# SERVICE BULLETIN

M-958

## TUBELESS TIRE VALVE STEM - 9-SPOKE WHEELS

This Service Bulletin concerns replacement valve stems for 9-spoke cast wheels.

Figure 1. Tubeless Tire Valve Stem

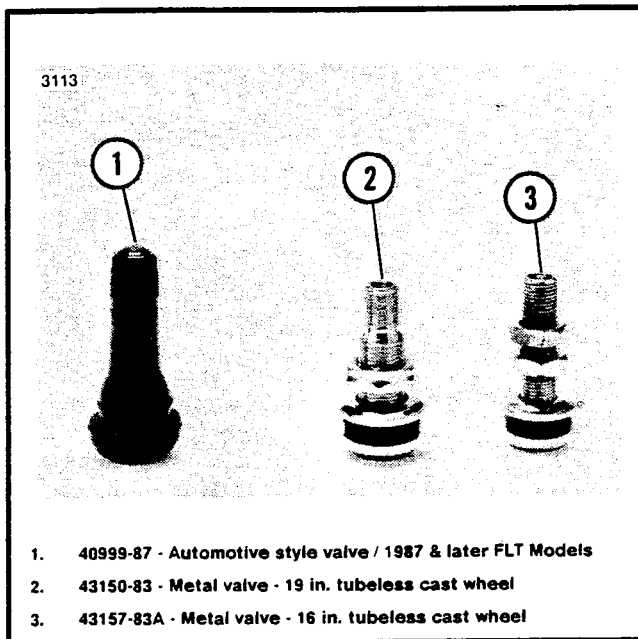
See Figure 1. When replacing valve stems on any vehicle with 9-spoke cast wheels, including those installed as part of the 062 recall program, the bolt-in style valve stem must be used.

**Use of the rubber automotive style valve stem in 9-spoke cast wheels could cause air loss and adversely affect handling.**
